TMCA SOUTH CENTRAL TOWER
LEVEL 03 REFRESH

ISSUE FOR CONSTRUCTION
VOLUME 1 OF 1

City of Aurora Building Division
Project: *Plan Revisions*
Address: *1501 S Potomac St*
Occupancy Group: *I2*
Construction Type: *IA-Spk*
RSN: *1777501*
Permit: *24-2410546-LT*

MARK	ISSUE	DATE
7	ADDENDUM #5	01.04.24
6	ADDENDUM #4	11.30.23
5	ADDENDUM #3	05.17.23
4	RFI 51	03.09.23
3	ADDENDUM #2	03.13.23
2	DFPC Revision #1	01.10.23
1	FGI REVIEW 1	09.16.22

3 TYPICAL HVAC PLAN - NORTH PATIENT ROOMS
3/8" = 1'-0"

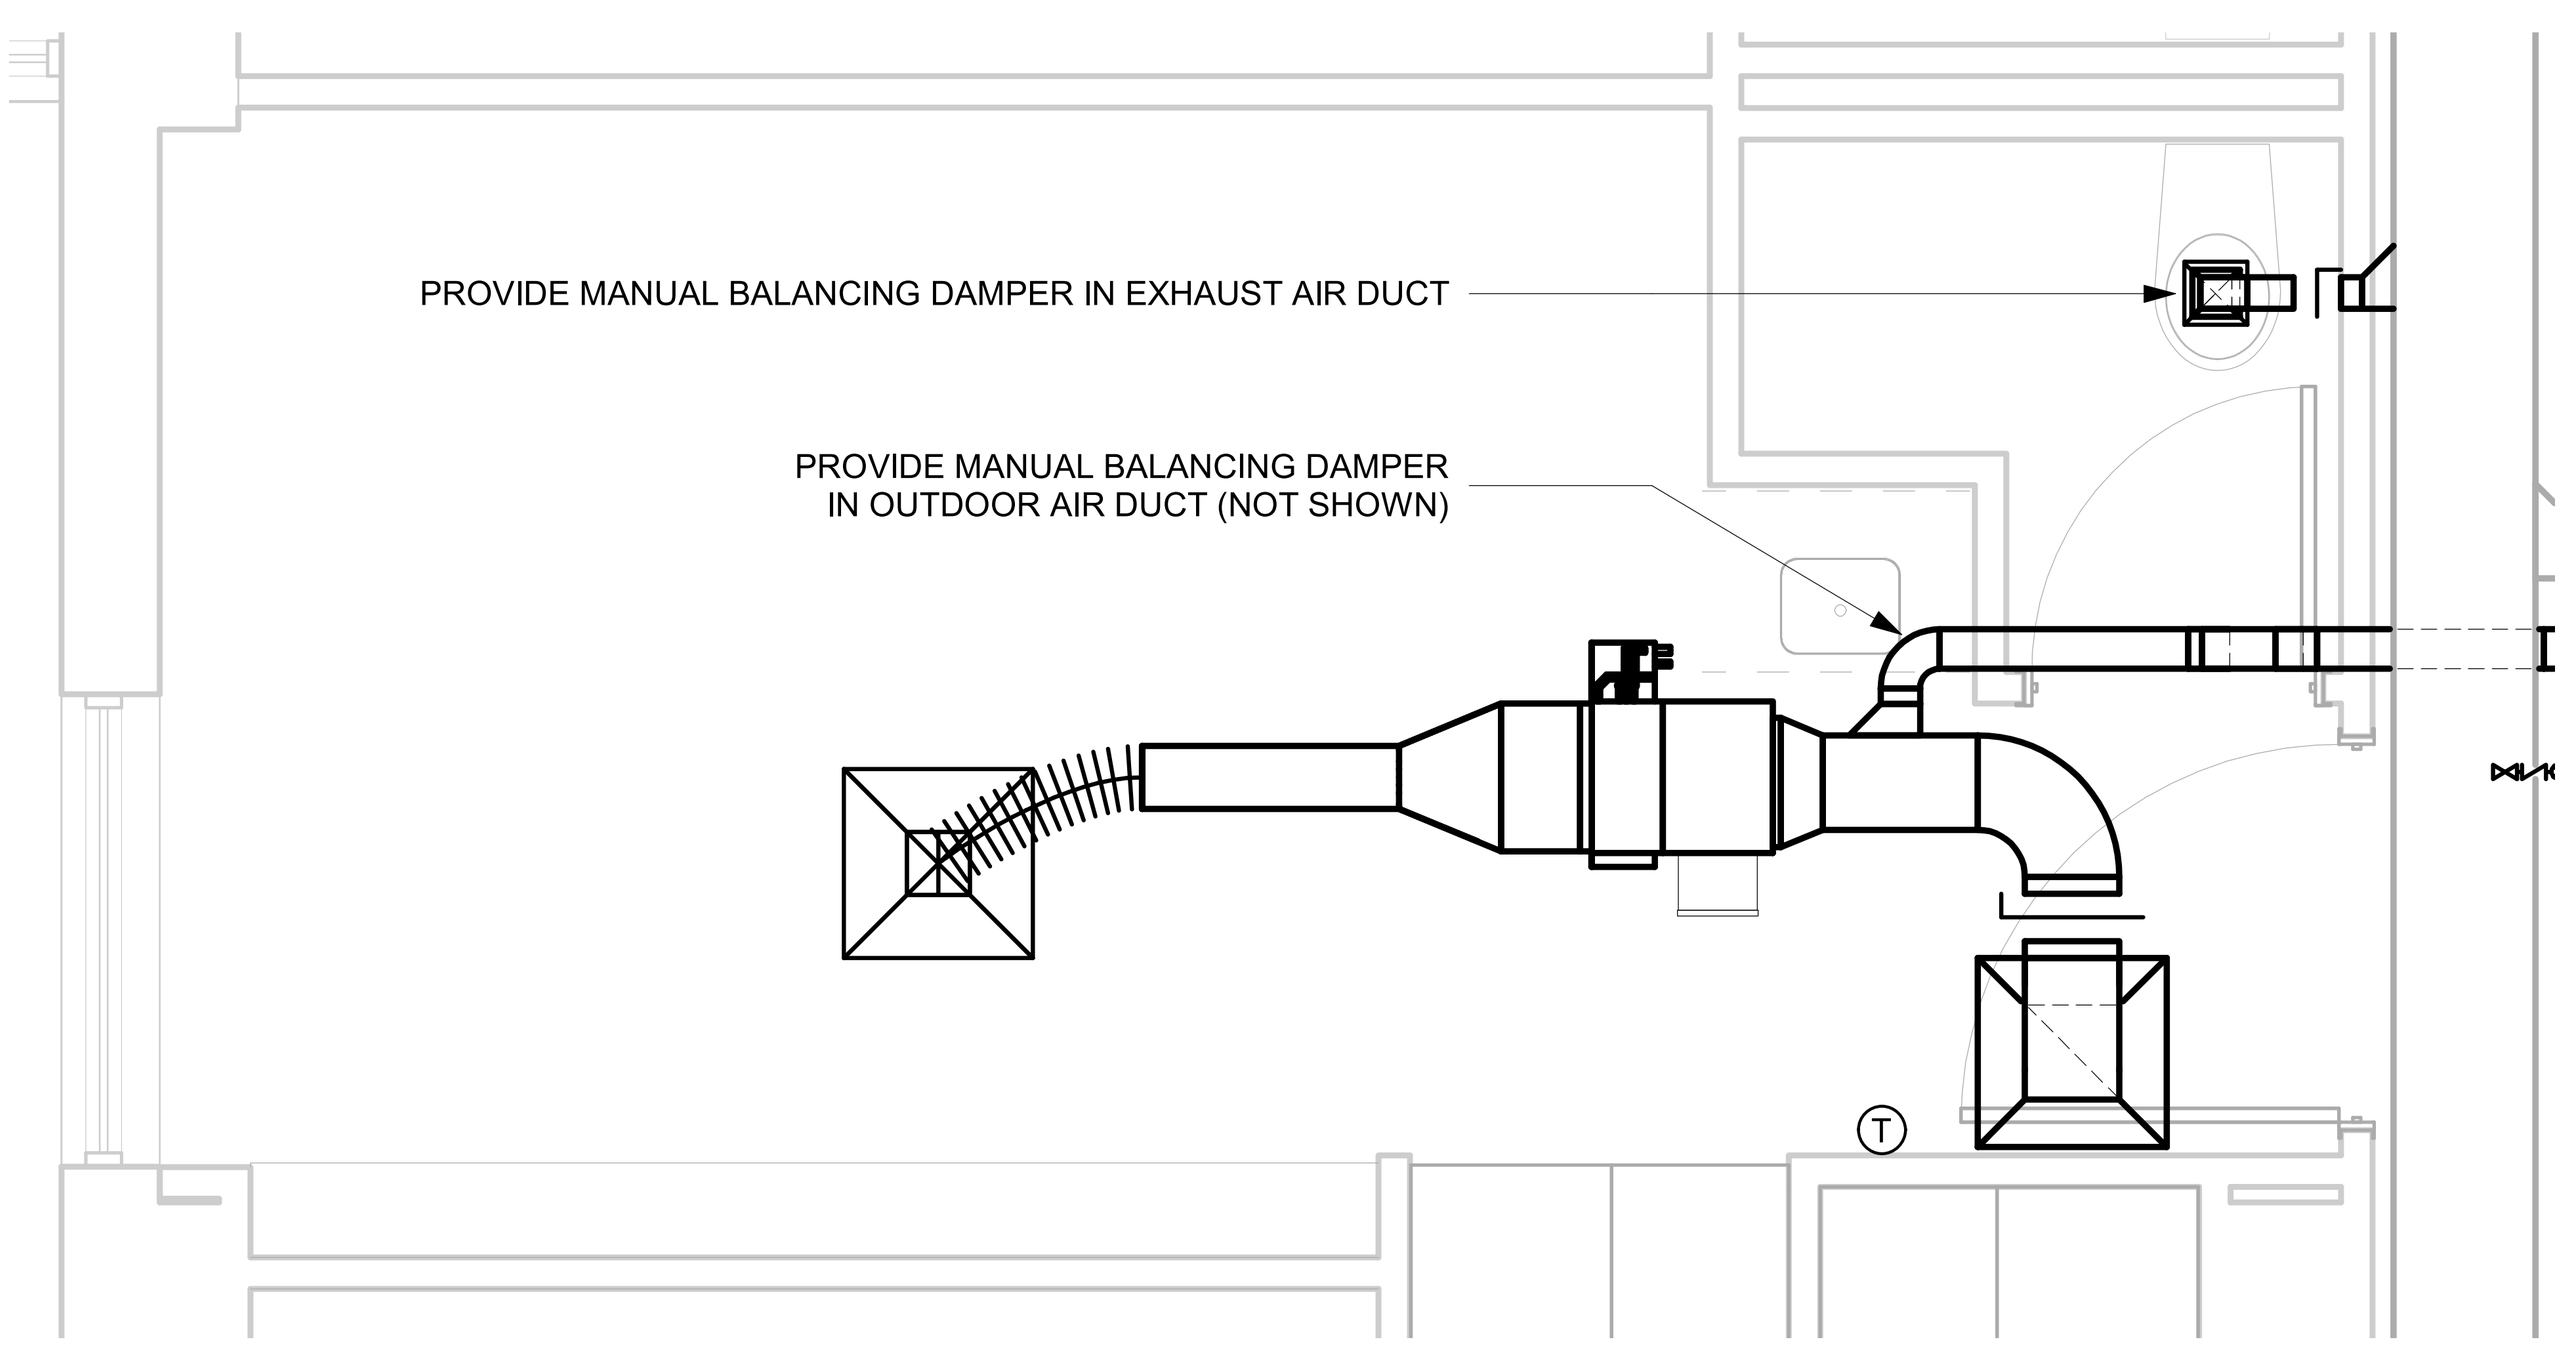
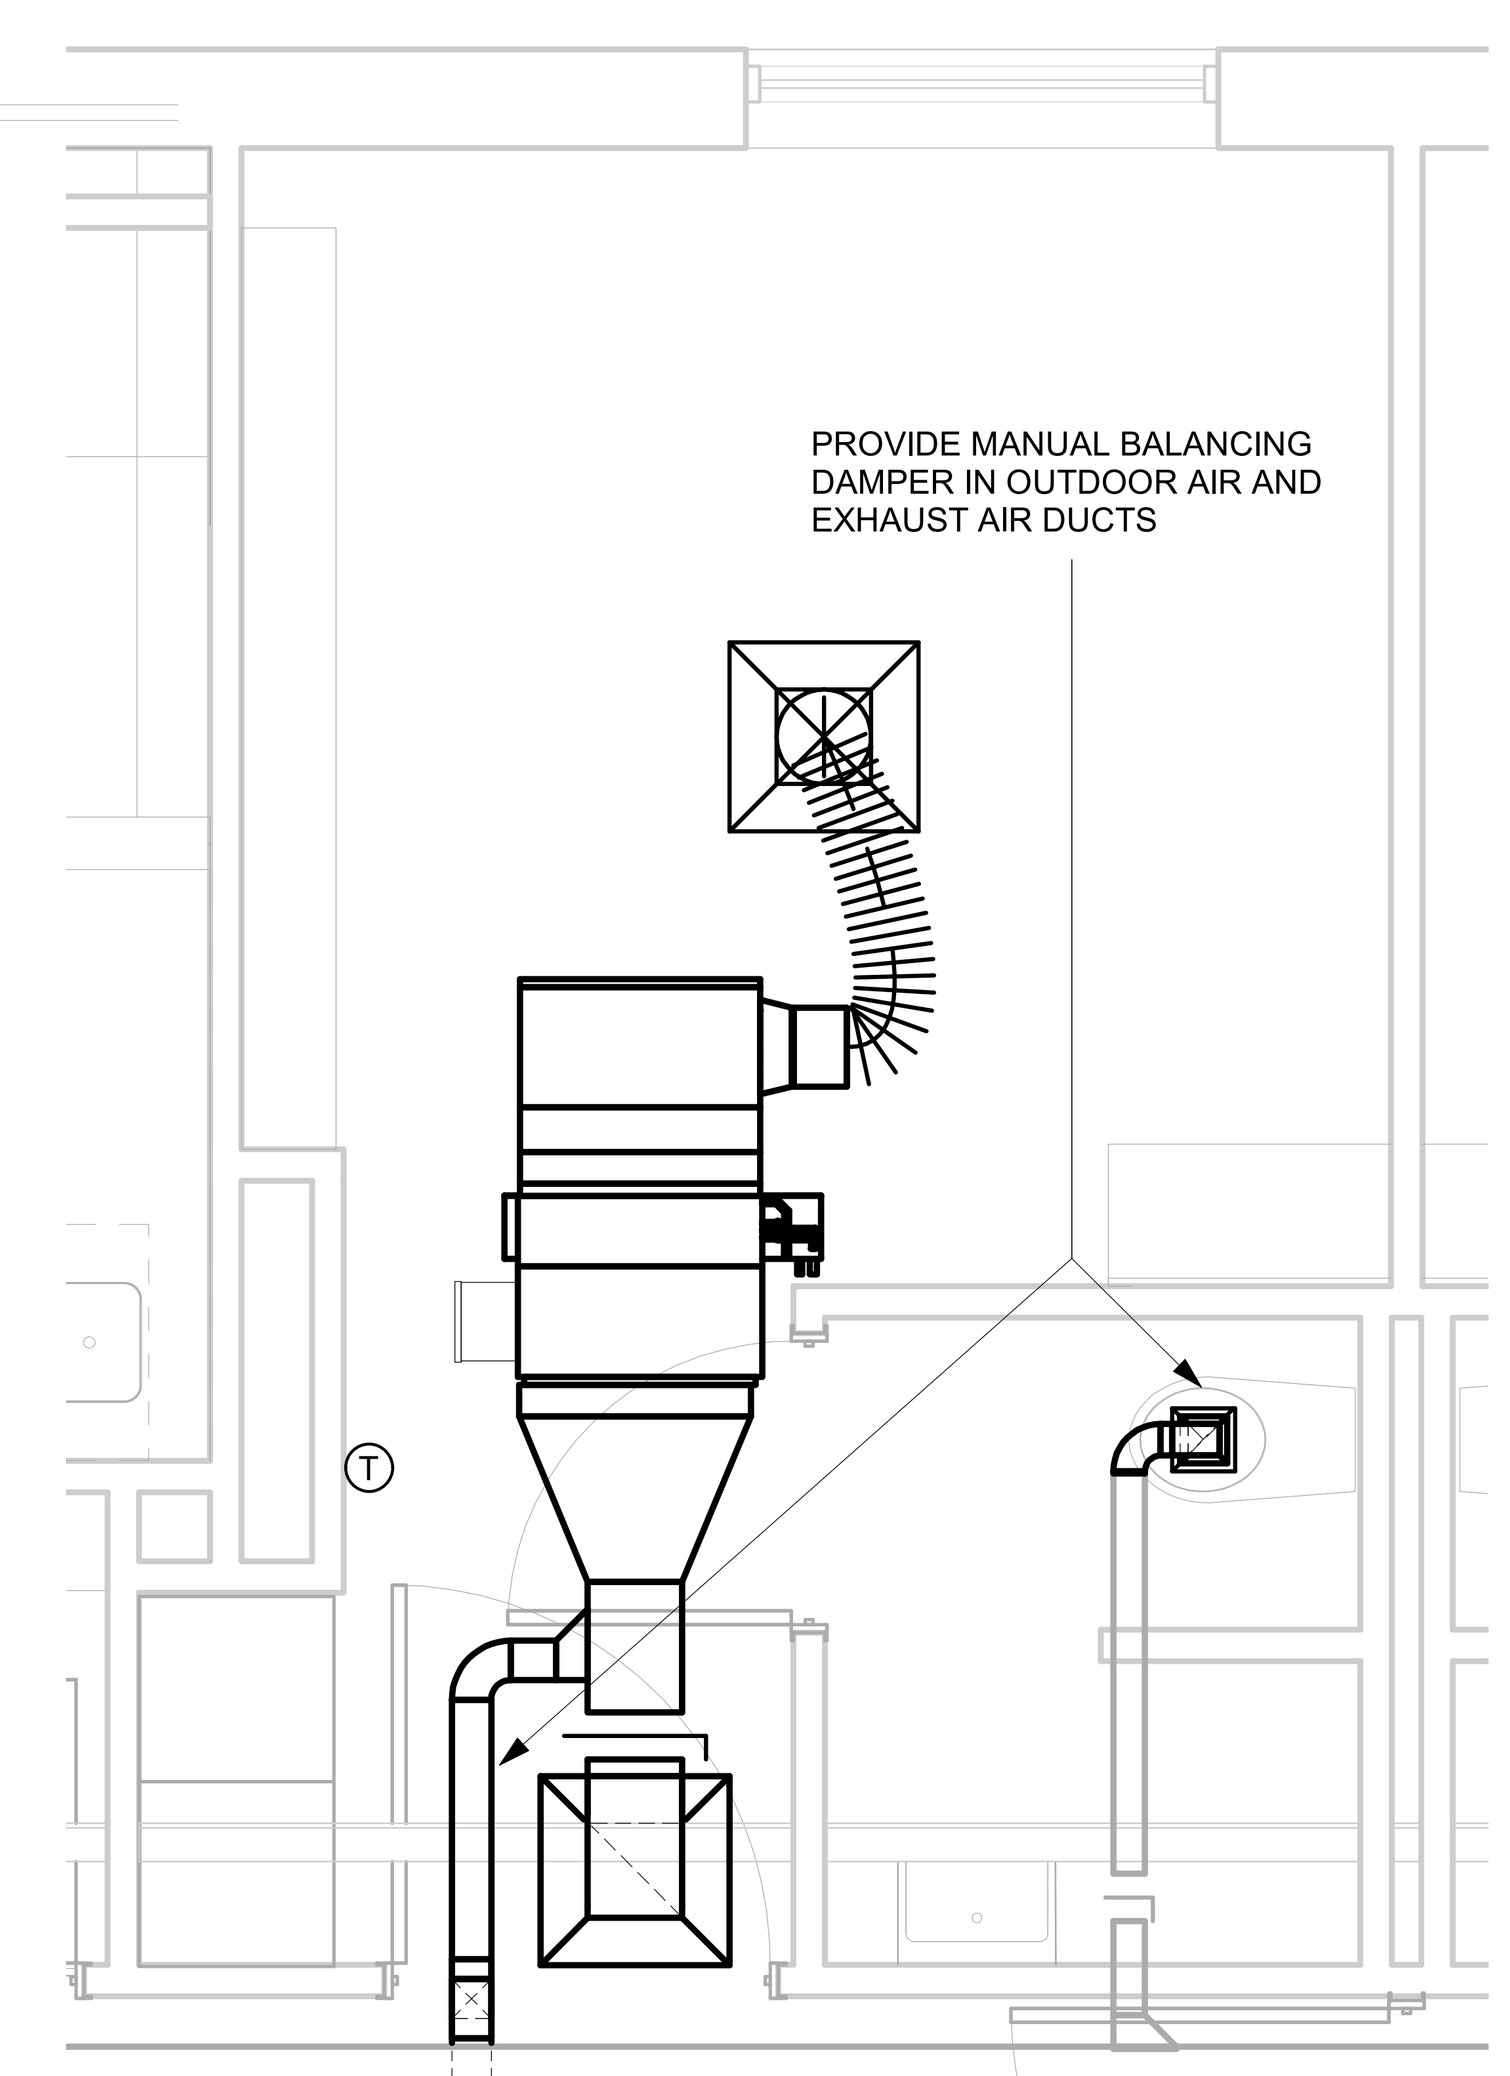
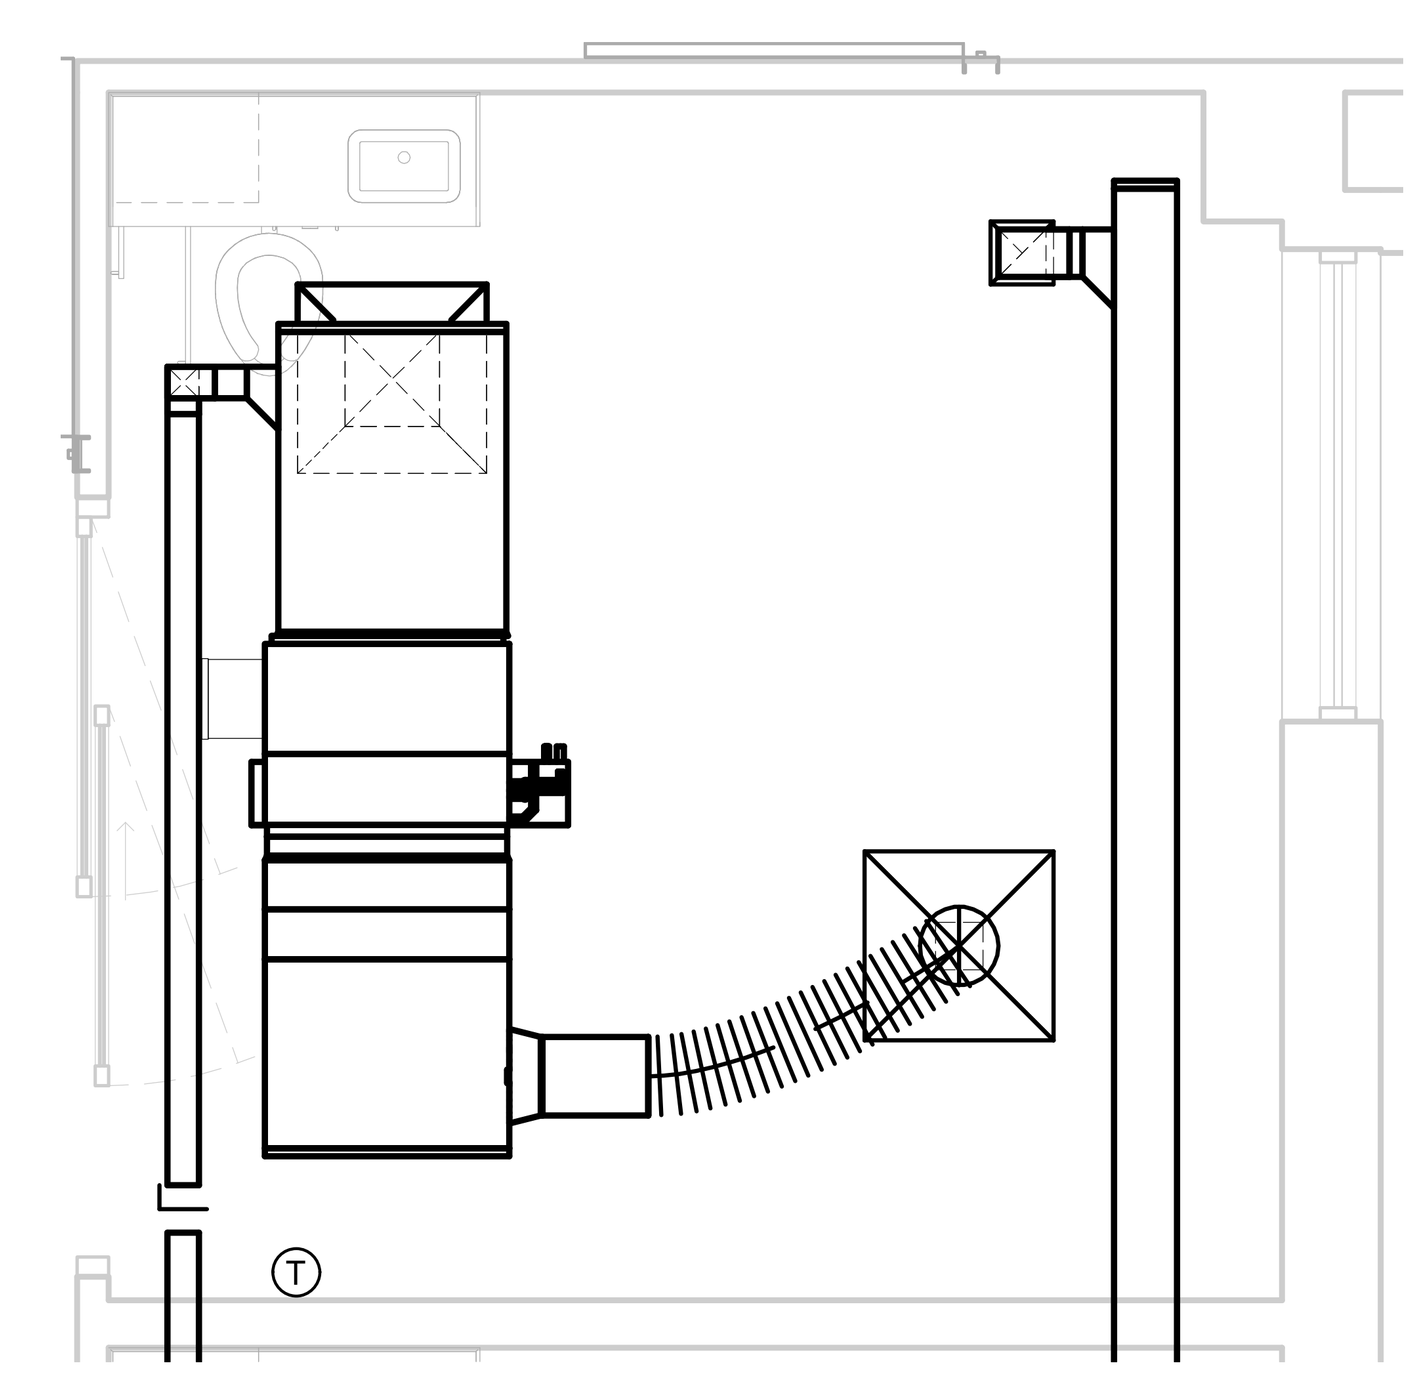
6. FAN COIL UNITS SHALL BE FULLY DUCTED TO SUPPLY AND RETURN GRD'S ~~WITH OUTDOOR AIR CONNECTED TO RETURN DUCT AS SHOWN.~~
7. REMOVED IN ADDENDUM #5.
